**Prairie Island Nuclear Generating Plant Corrective Actions
for Generic Letter 2004-02**

The U.S. Nuclear Regulatory Commission (NRC) is auditing, on a sample basis (related to reactor type, containment type, strainer vendor, NRC regional office, and sump replacement analytical contractor), licensee corrective actions for Generic Letter (GL) 2004-02, "Potential Impact of Debris Blockage on Emergency Recirculation During Design Basis Accidents at Pressurized-Water Reactors," dated September 13, 2004 [1], for approximately ten commercial pressurized water reactors (PWRs). The purpose of the audits is to verify, to the extent feasible, that the implementation of Generic Safety Issue (GSI-191) 191, "Assessment of Debris Accumulation on PWR Sump Performance [2]" sump strainer and related modifications will bring those reactor plants into full compliance with 10 CFR 50.46, "Acceptance Criteria for Emergency Core Cooling Systems for Light-water Nuclear Power Reactors," and related requirements, and to draw conclusions as to the probable overall effectiveness of GL 2004-02 corrective actions for the 69 U.S. operating PWRs.

Figure 3 Prairie Island Strainer Assembly Top View

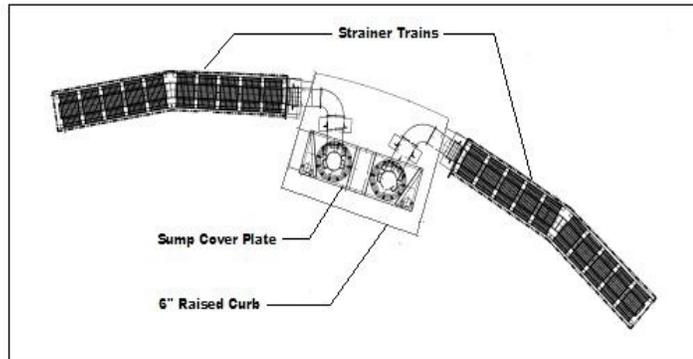
There are 10 modules in each strainer train (Figure 3), a core tube, and mounting tracks. The modules are essentially identical with the only difference being the hole sizes in the core tube. Each module is independently supported. The modules are connected with thin gauge stainless steel bands that are used to prevent debris from entering the system between the two modules. This connection permits relative motion in the axial direction as the core tube can slide relative to the stainless steel bands.
